Dynamics of avalanche-generated impulse waves: three-dimensional hydrodynamic simulations and sensitivity analysis

Response to Reviewers nhess-2017-98

Figure 1: Location of Lake Palcacocha within the Cordillera Blanca, Peru.

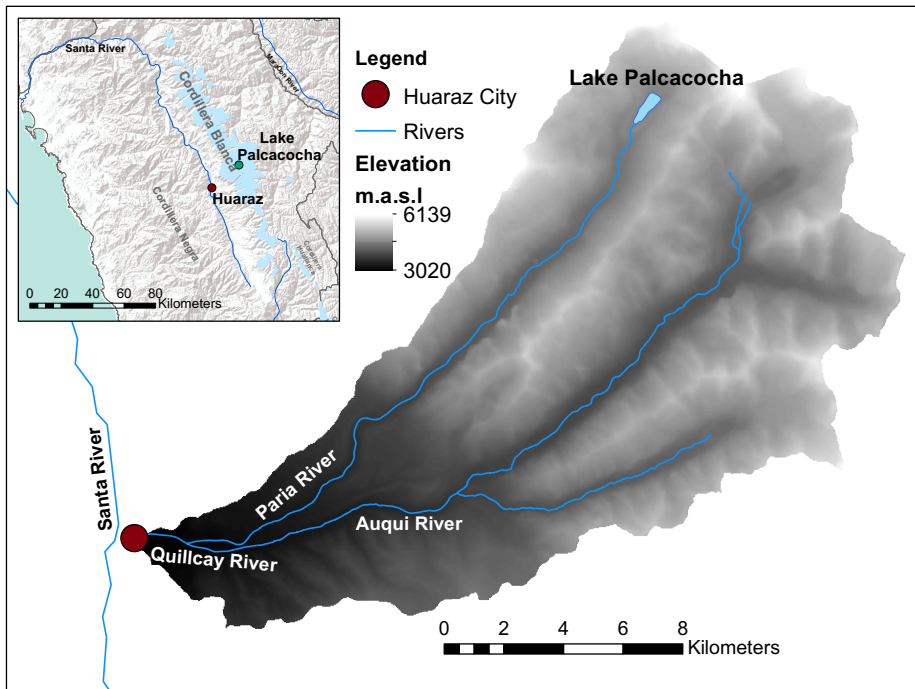
Figure 1: Consider using hillshading to better visualize topography (see Fig. 1 in Somos-Valenzuela et al. 2016). In addition, adding glaciated areas would be helpful.

We have considered this suggestion, and we decided that the current figure is adequate for the purposes of this paper.
